Evaluation Kit for RA8M1 Microcontroller Group
EK-RA8M1 v1
Errata

Renesas RA Family
RA8 Series

EK-RA8M1 v1 – Errata

Figure 1. SparkFun® Qwiic Connector SCL and SDA Pins

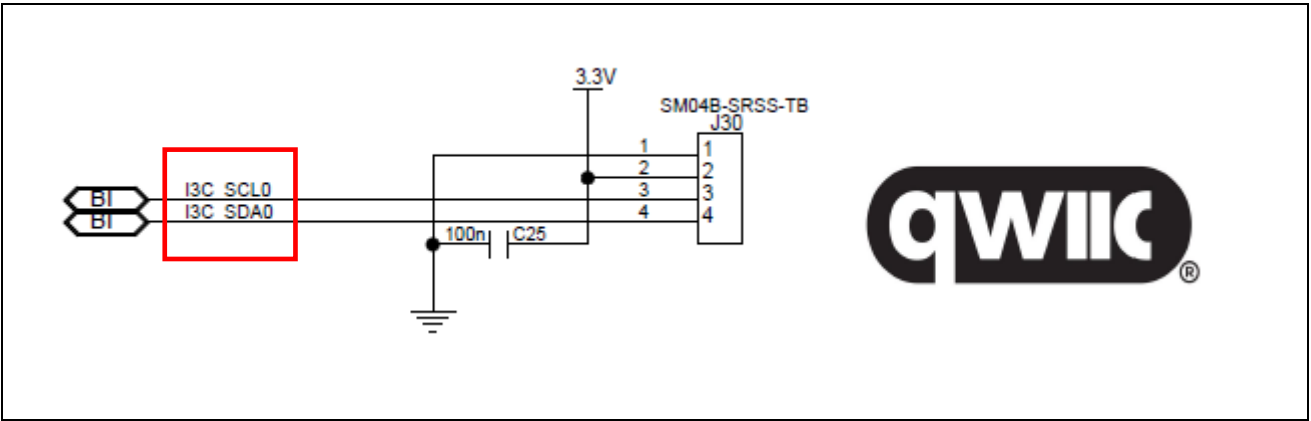
The SparkFun® Qwiic connector (J30) on the EK-RA8M1 has incorrectly transposed SCL and SDA pins as compared to the SparkFun® Qwiic definition.

The error appears in section 5.3.2 SparkFun® Qwiic Connector of the *EK-RA8M1 v1 User’s Manual* (document number *r20ut5149eg*) and is also reflected in the schematic.

Qwiic Connector		EK-RA8M1
Pin	Description	Signal/Bus
J30-1	GND	GND
J30-2	VCC	+3.3 V
J30-3	I3C_SCL*	P400 (SCL0)
J30-4	I3C_SDA*	P401 (SDA0)

*Transposed pins.

Please manage the connection swap by modifying the cable.

The SCL and SDA pins will be correctly assigned in later versions of the kit.

Figure 2. USB High Speed series 33 Ω resistors (R83 and R84)

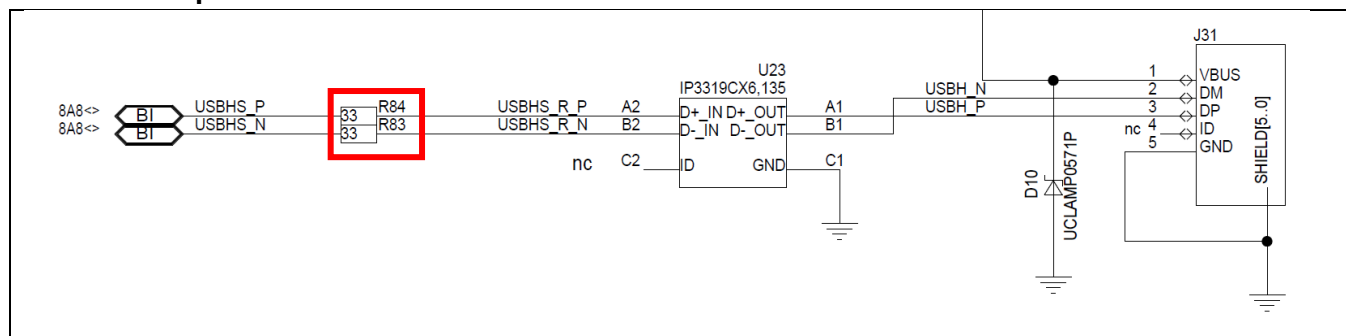
Both data pins of the USB high speed port (J31) are connected to the MCU via 33 Ω resistors (R83 and R84). This has caused issues with connection to USB 3.0 ports. Replacing these resistors with 0 Ω resistors fixes this issue.
